Addendum 2

Project Stadium New Press Box – Marlin ISD
Issued December 8, 2023 by CEI Engineering Associates, Inc.
Proposal Opening December 14th at 2:00 PM

ADDENDUM NO. 2

PROJECT: Marlin ISD - Pressbox
HKS Project No. 26095.000

9 ELEVATOR SECTION
1/4" = 1'-0"

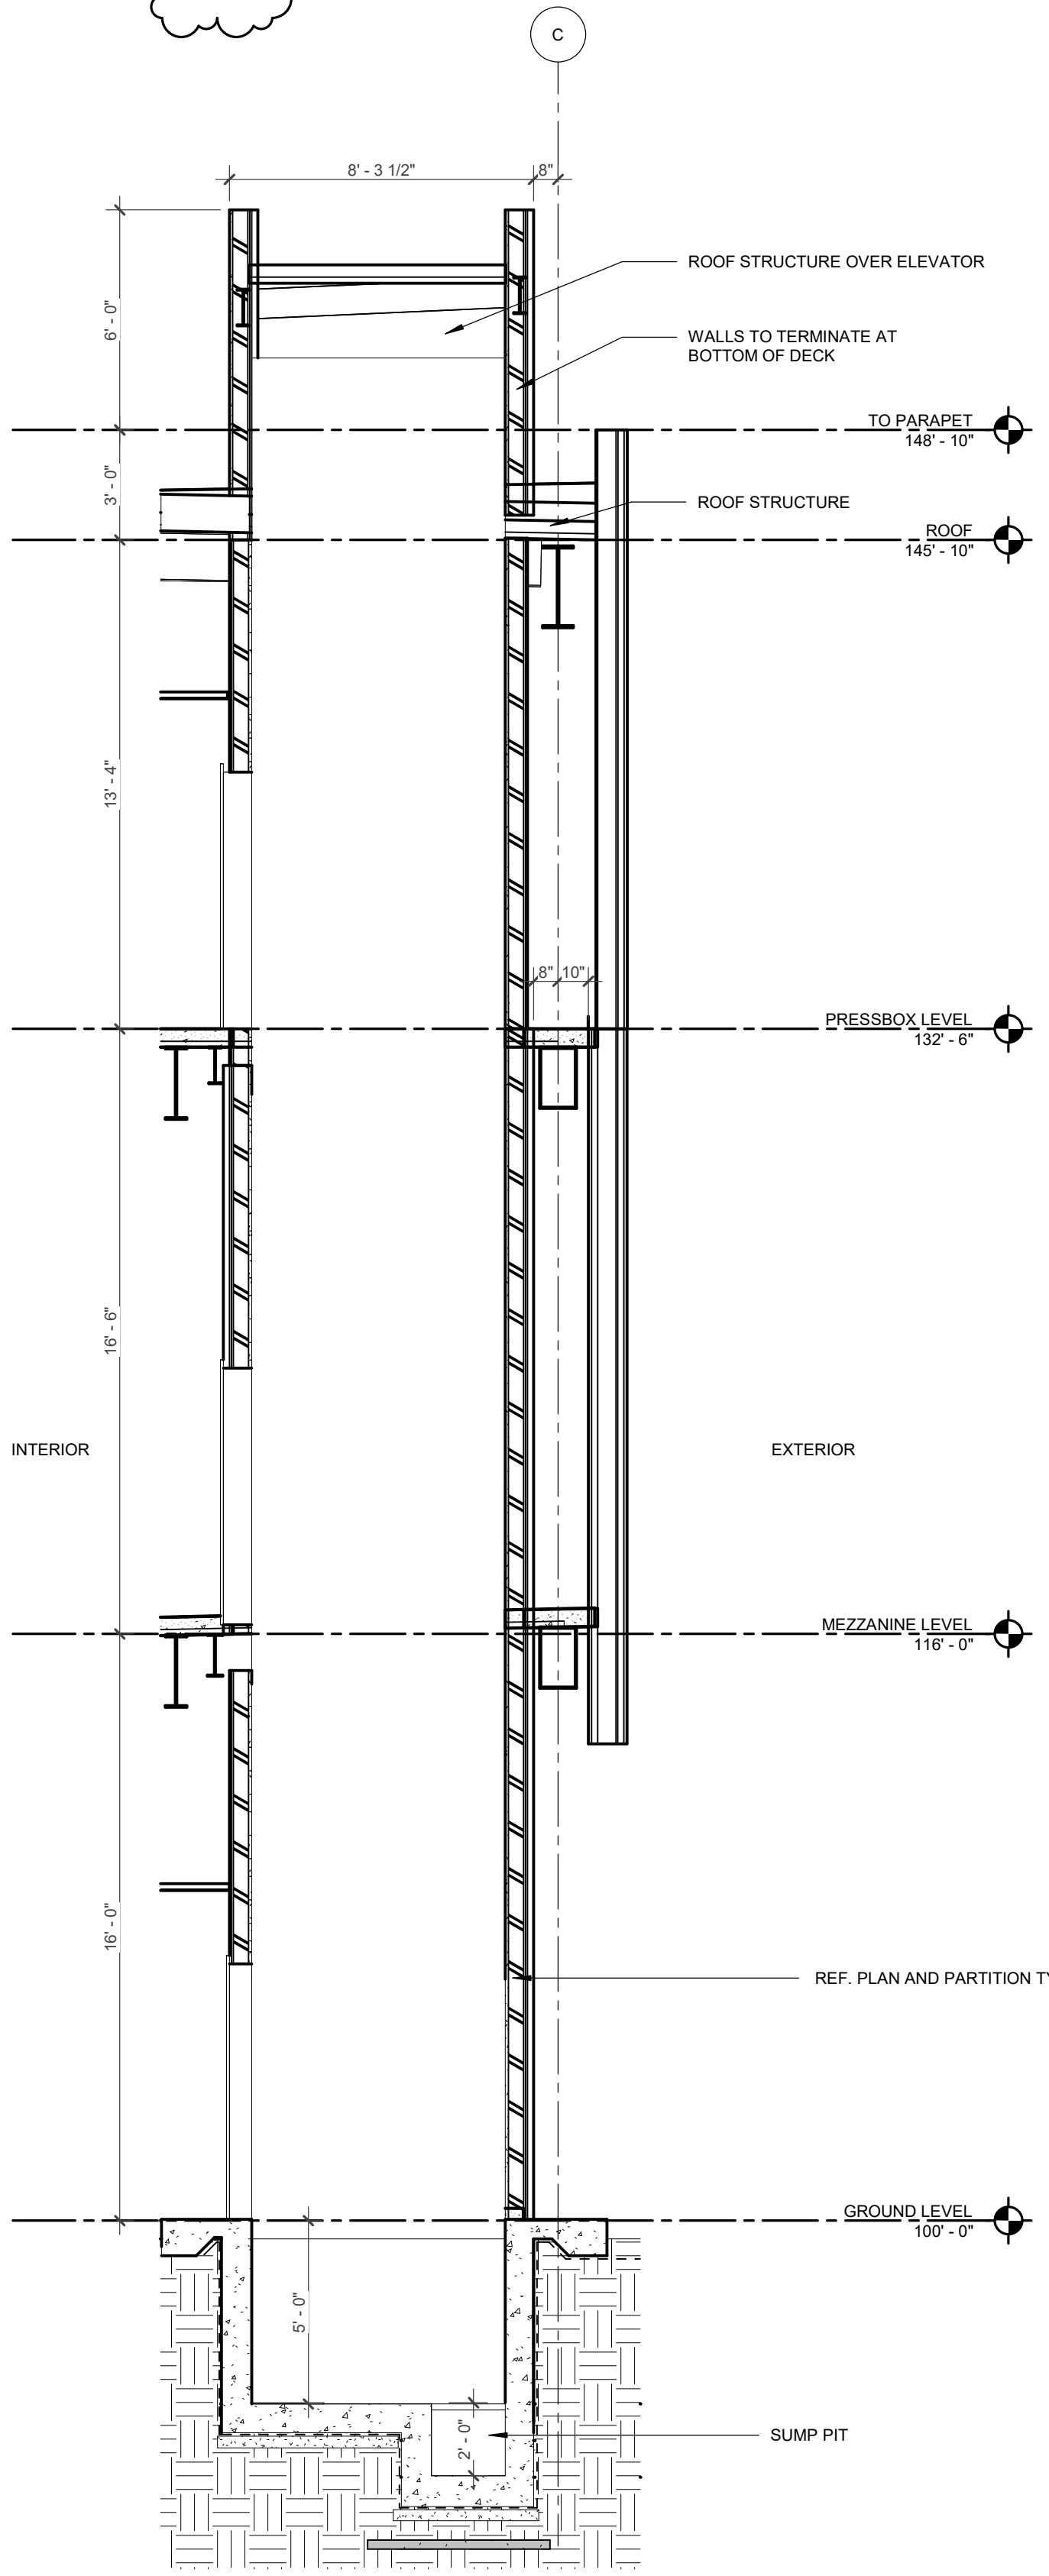
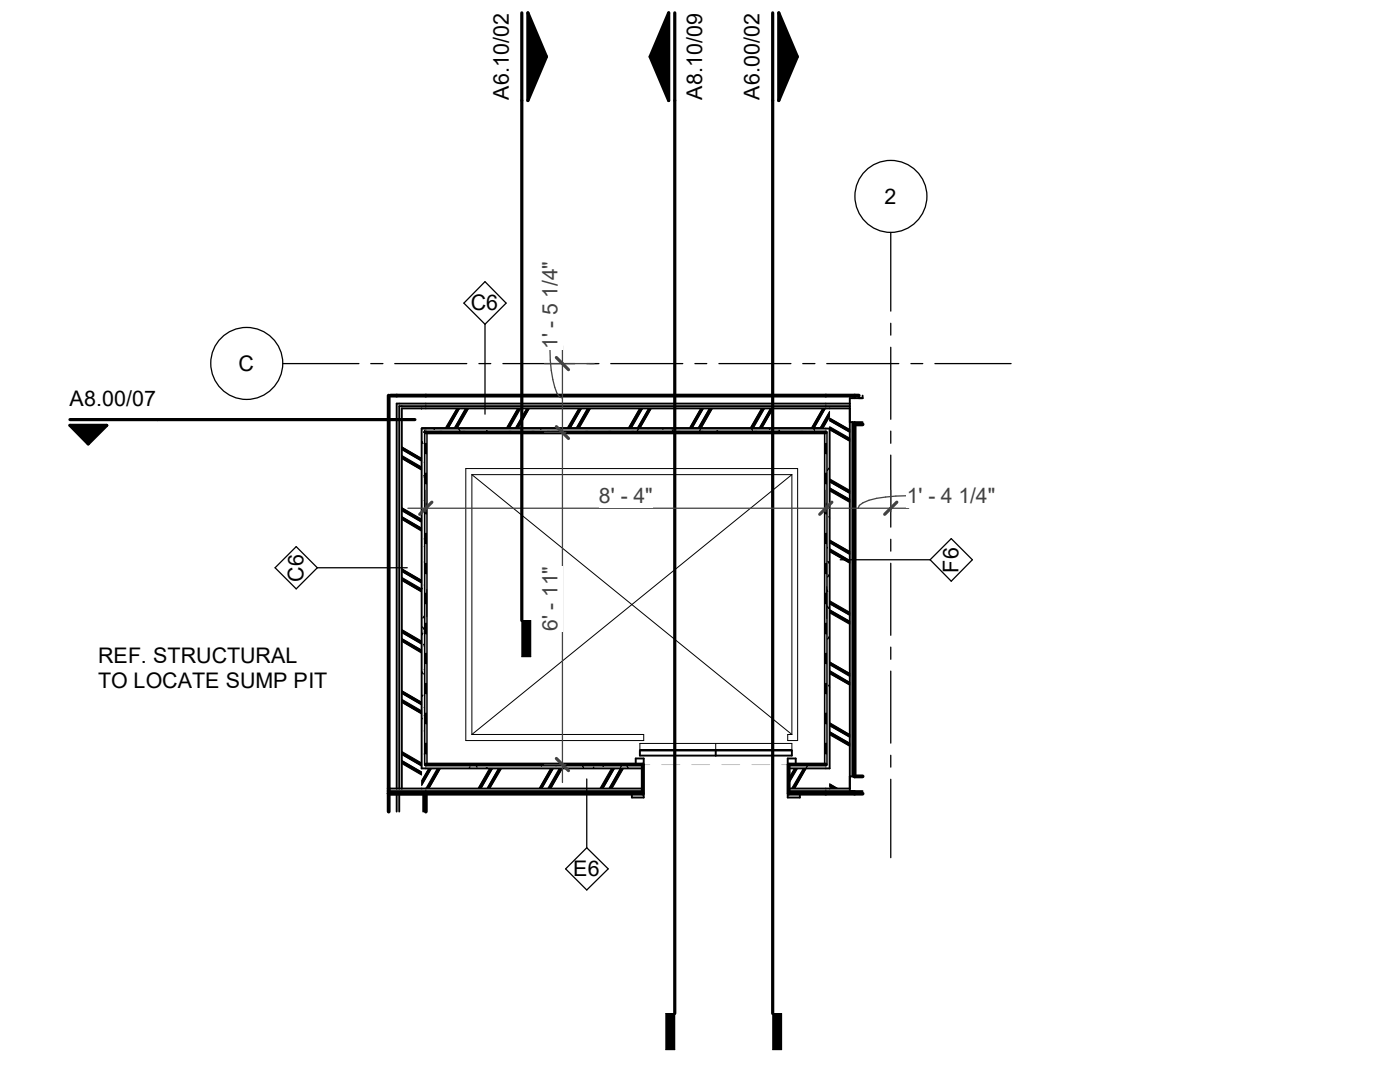
- **A5.10 – WINDOW ELEVATIONS**
 - Updated height of window at South Elevation Pressbox
 - Updated height of East Elevation window
- **A6.10 – WALL SECTIONS**
 - Changed view extents to show interior wall at stairwell
 - Added Section 02 for elevator shaft
- **A6.11 – WALL SECTIONS**
 - Added additional information to Section 07
- **A7.10 – METAL PANEL DETAILS 01**
 - Added details 09,10, and 11
- **A7.11 – METAL PANEL DETAILS 02**
 - Added detail 04
- **A8.00 – STEEL STAIR PLANS AND SECTIONS**
 - Updated Stair plans 01 and 02 to show structural columns
- **A8.10 – ELEVATOR PLAN AND DETAILS**
 - Updated Views 09 and 13

08 ELEVATOR SECTION N-S
3/4" = 1'-0"

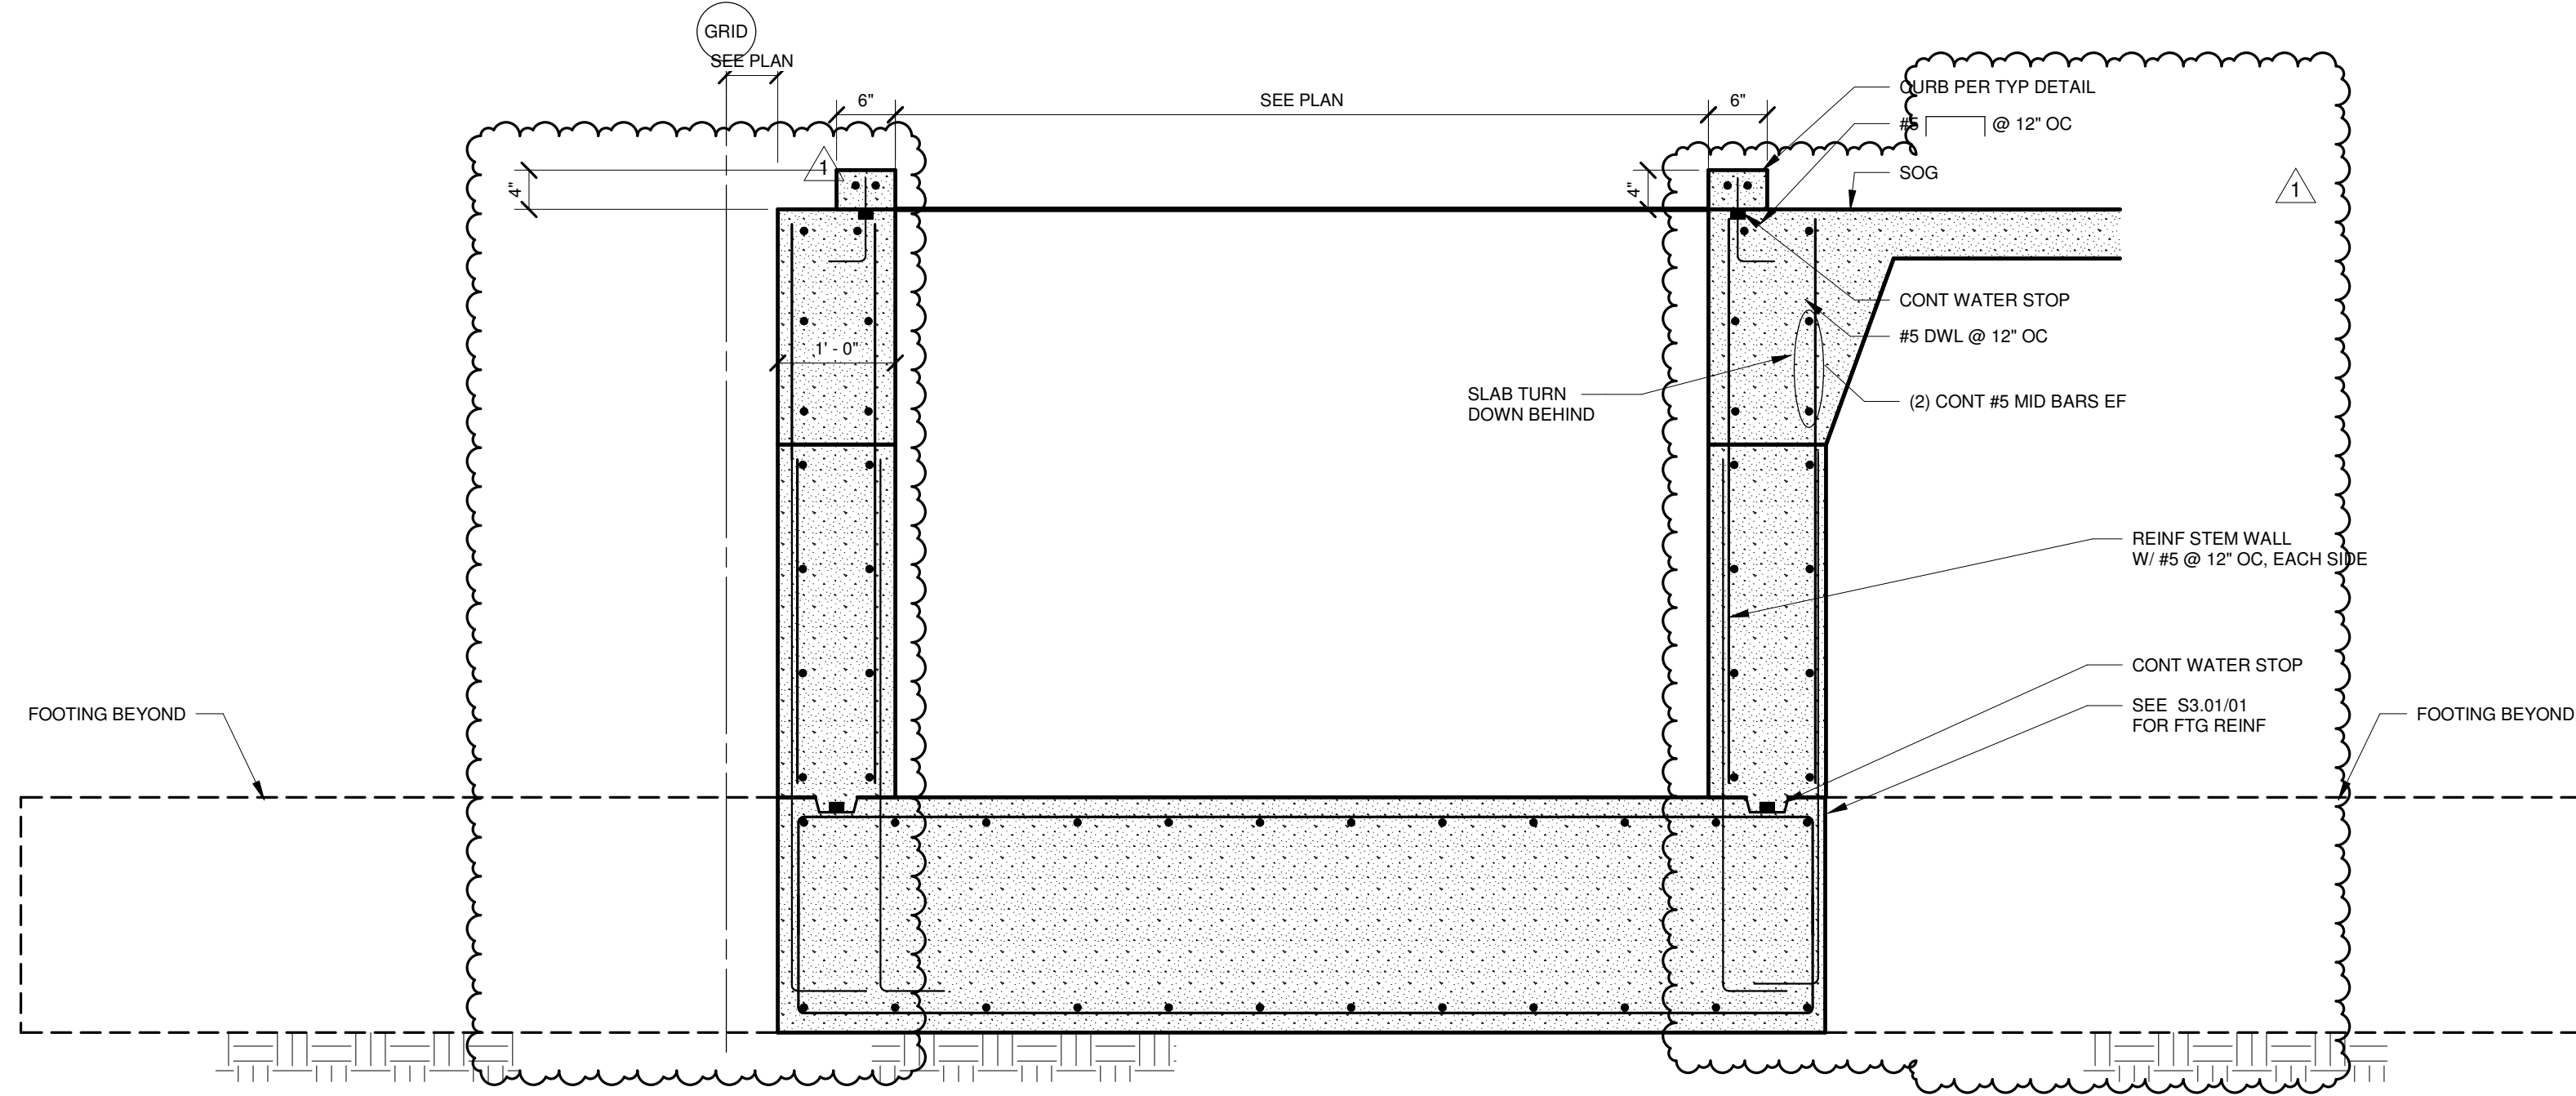
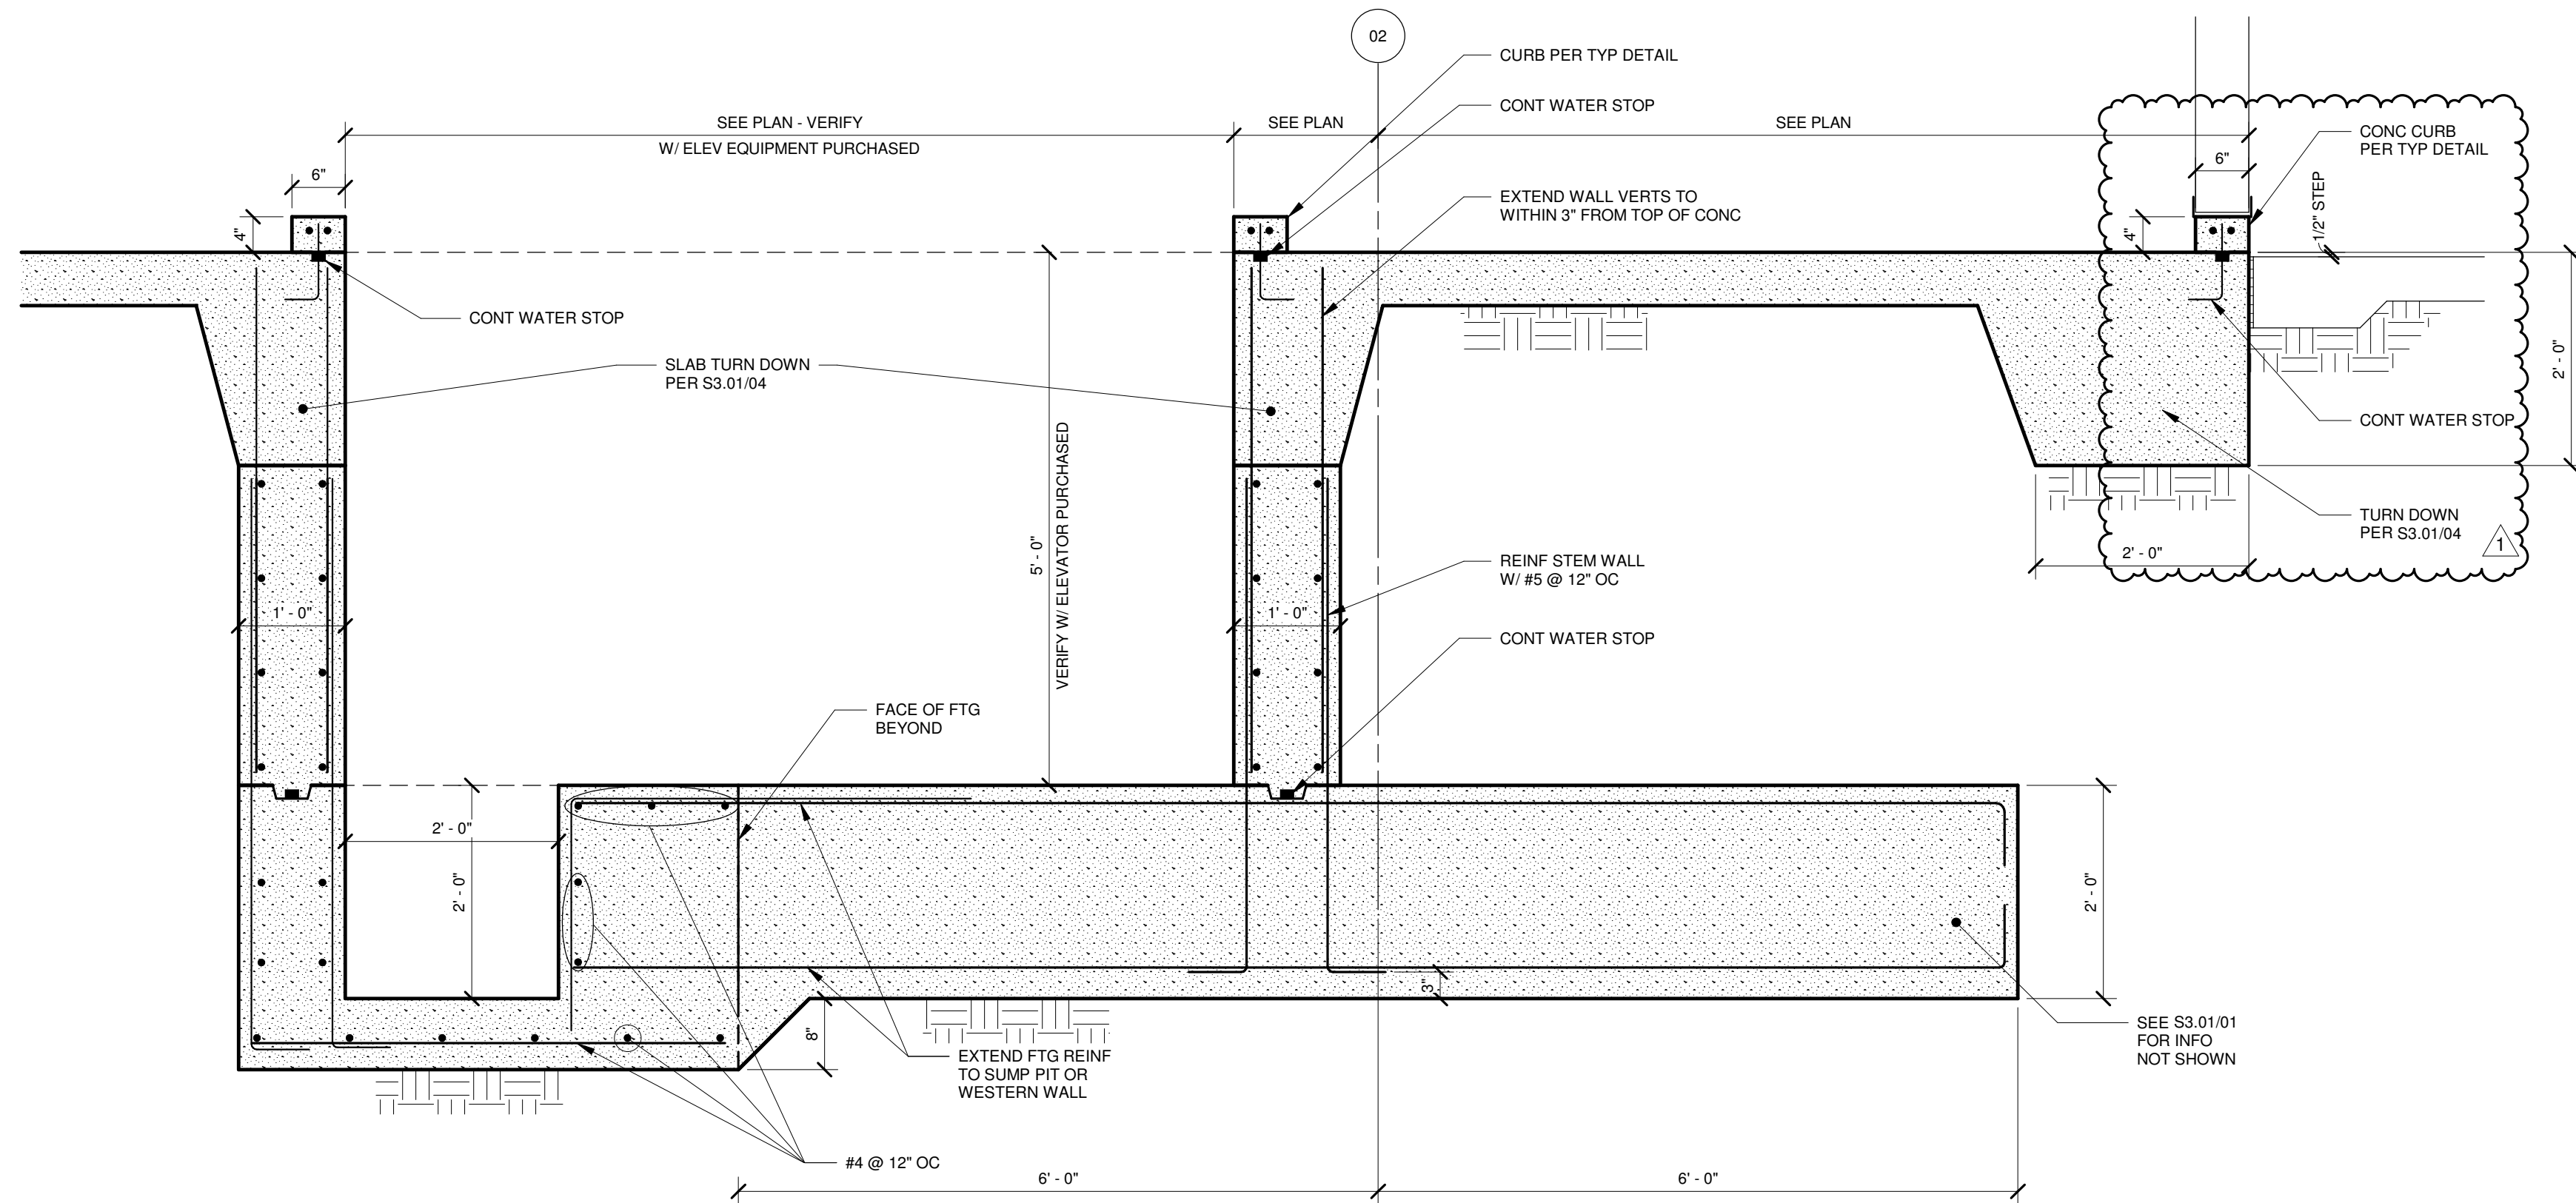
Updated the elevator foundation details 07 and 08 to reflect new design intent.
